Attached for your review is the *Revised Data Gap Work Plan Addendum* for former Chevron-branded service station 91723, located at 9757 San Leandro Street in Oakland, California. This document was prepared by Stantec Consulting Services Inc. (Stantec), upon whose assistance and advice I have relied. I declare under penalty of perjury that the information and/or recommendations contained in the attached report are true and correct, to the best of my knowledge.

**Reference: Revised Data Gap Work Plan Addendum**  
Former Chevron-Branded Service Station 91723  
9757 San Leandro Street, Oakland, California

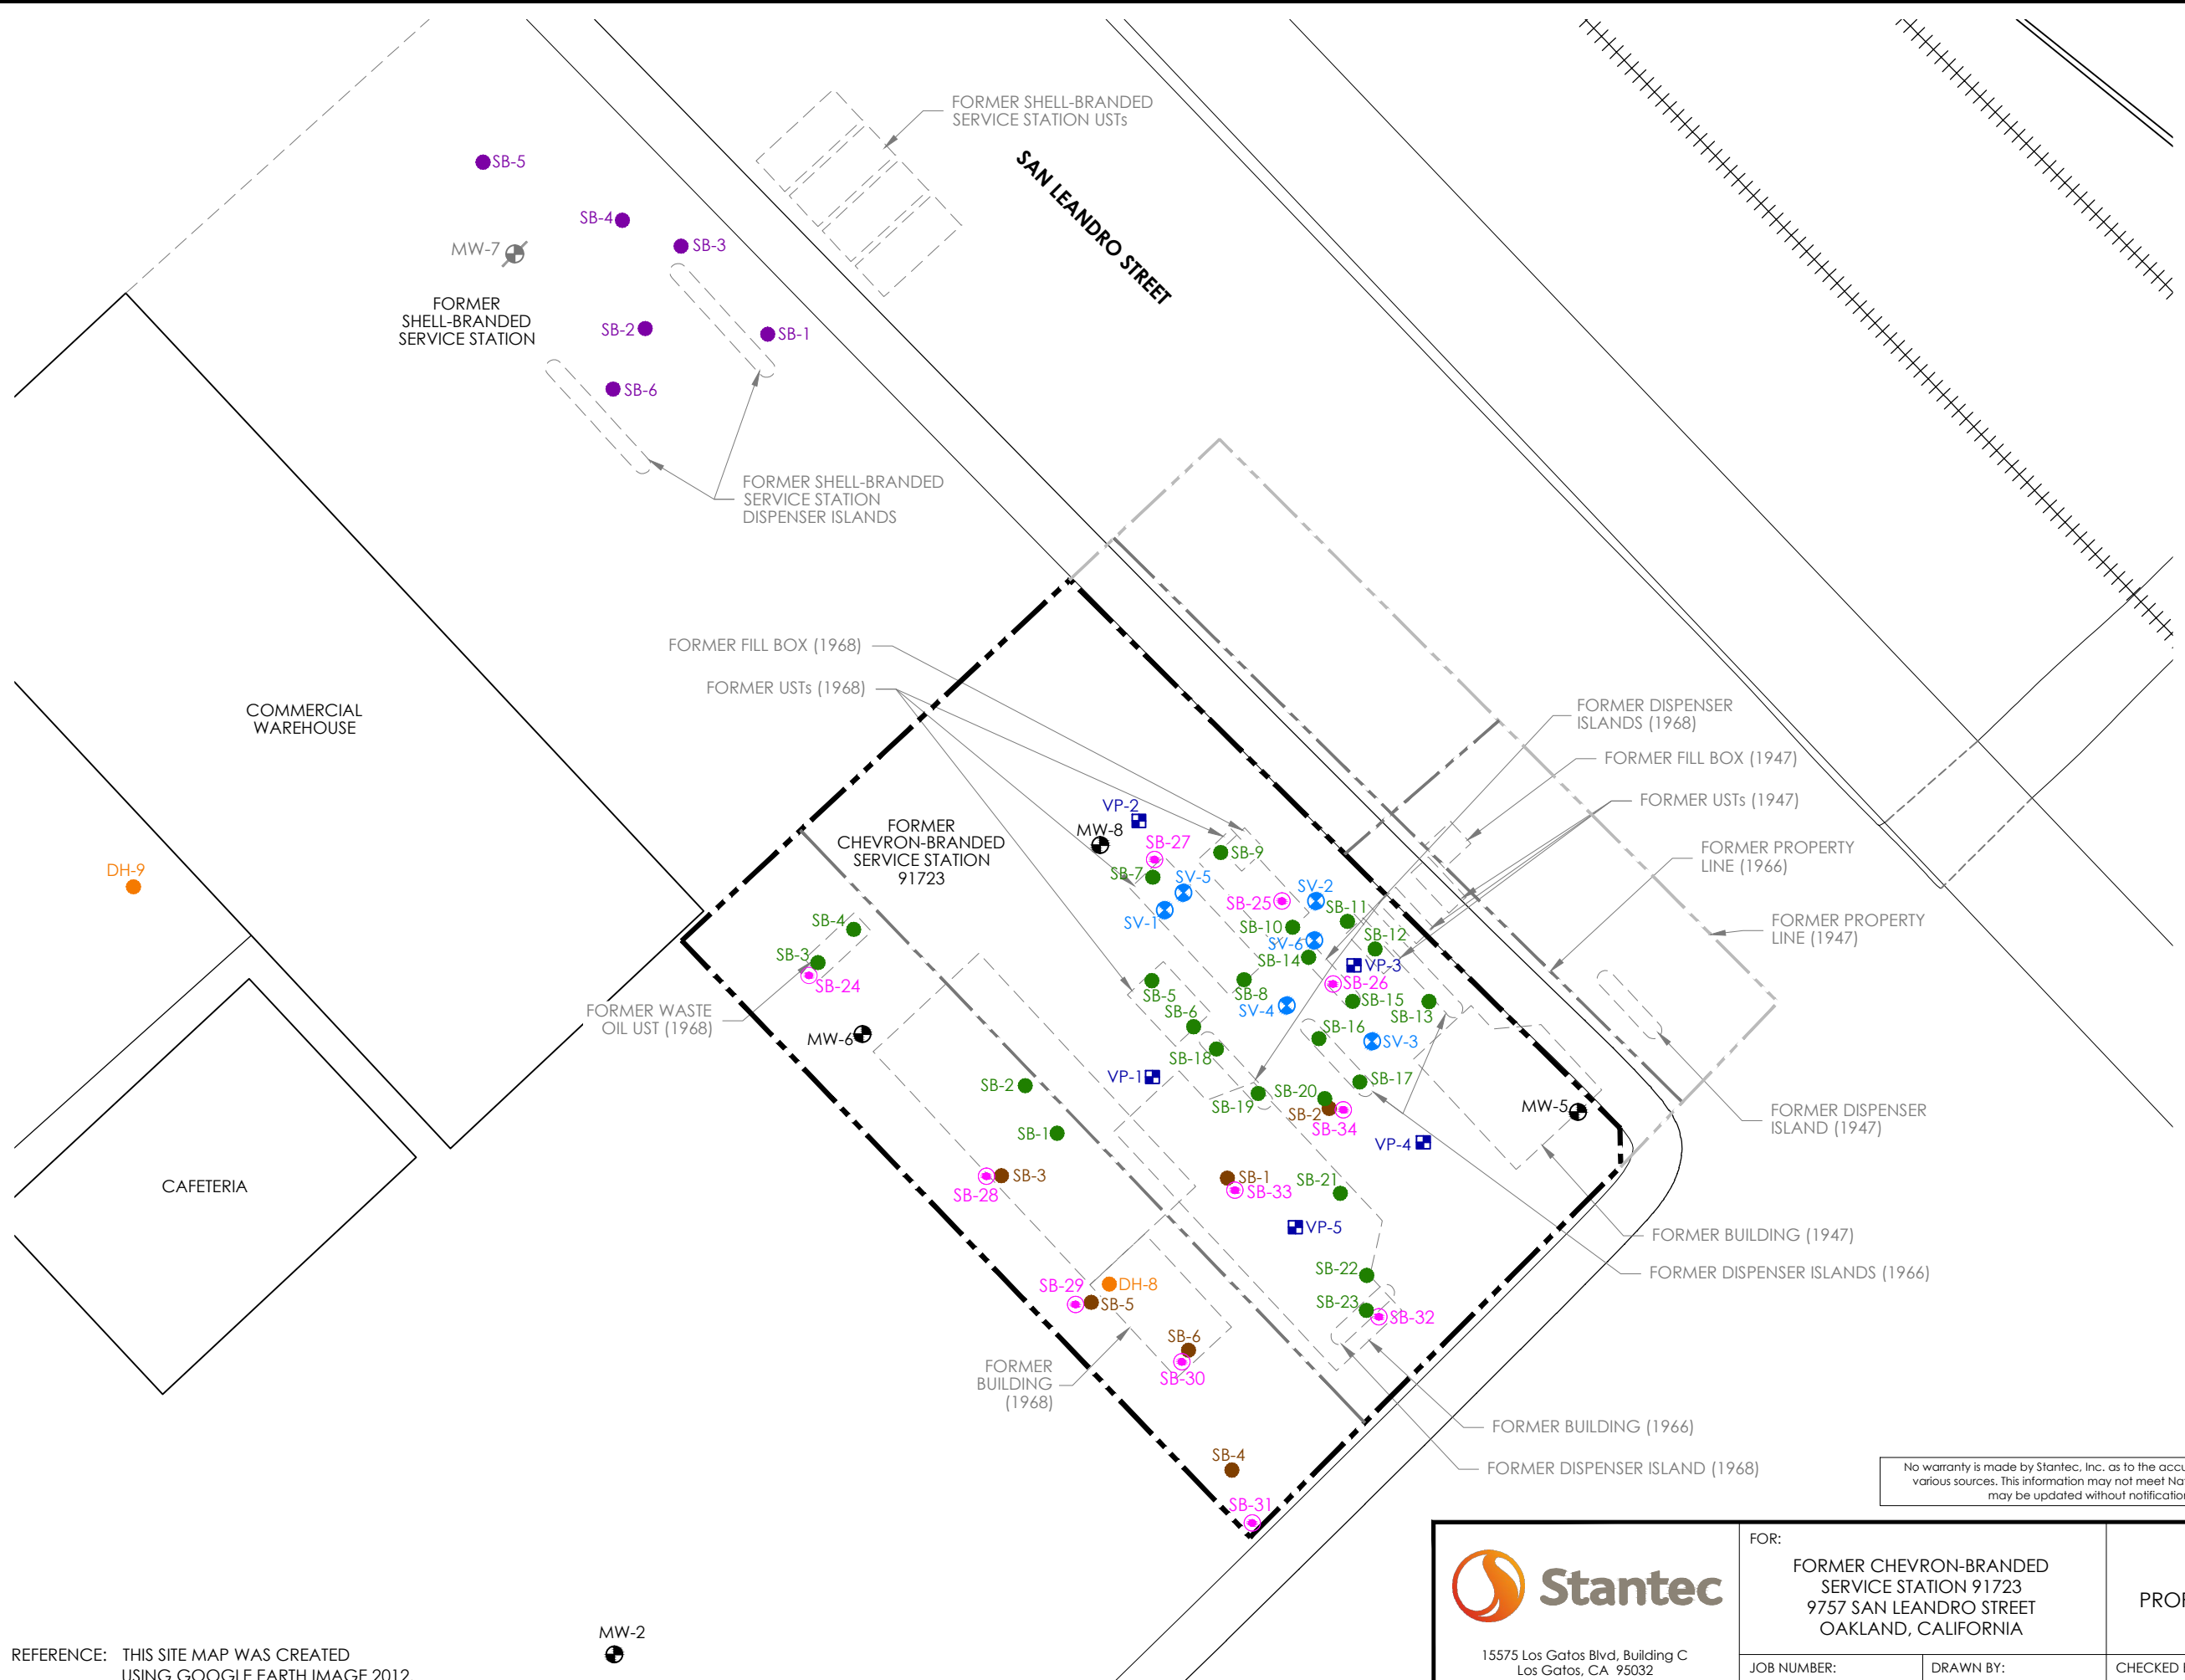
**1. ACEH is concerned that there was a waste oil underground storage tank (UST) release at the Site and that it could have caused a secondary release to groundwater.**

- 2. ACEH is concerned about the lateral delineation of petroleum hydrocarbons in soil and would like to see additional confirmation soil borings and a comparison of current and historical concentrations to 15 feet bgs.**

*To address this concern, Stantec proposes that soil boring SB-24 (proposed directly adjacent to, and down-gradient from, the former waste oil UST; shown on **Figure 1**) be advanced to approximately 12 feet below ground surface (bgs) or approximately 2 to 3 feet into first-encountered groundwater (which was approximately 10 feet bgs during Third Quarter 2014). A grab-groundwater sample will then be collected from boring SB-24. Following advancement of boring SB-24 to total depth, a temporary pre-packed groundwater monitoring well casing will be installed, and a groundwater sample will be collected using a disposable bailer. Prior to groundwater sampling, depth-to-groundwater will be measured and used to calculate the three casing-volumes that will be purged from the casing prior to collecting the groundwater sample. If the boring does not produce sufficient water, a groundwater sample may be collected without purging the desired volume. The groundwater sample will be collected in sample containers appropriate for the specified analyses, sealed, labeled, and placed into an ice-filled cooler for preservation.*

*To address this concern, Stantec proposes additional on-site soil borings SB-27 through SB-34 (shown on **Figure 1**) in the areas of highest historical soil concentrations. Each soil boring will be advanced to a total depth of approximately 15 feet bgs, with soil samples collected at approximately 2.5-foot intervals. The soil samples collected from these borings will be analyzed for benzene, toluene, ethylbenzene, total xylenes, and naphthalene.*
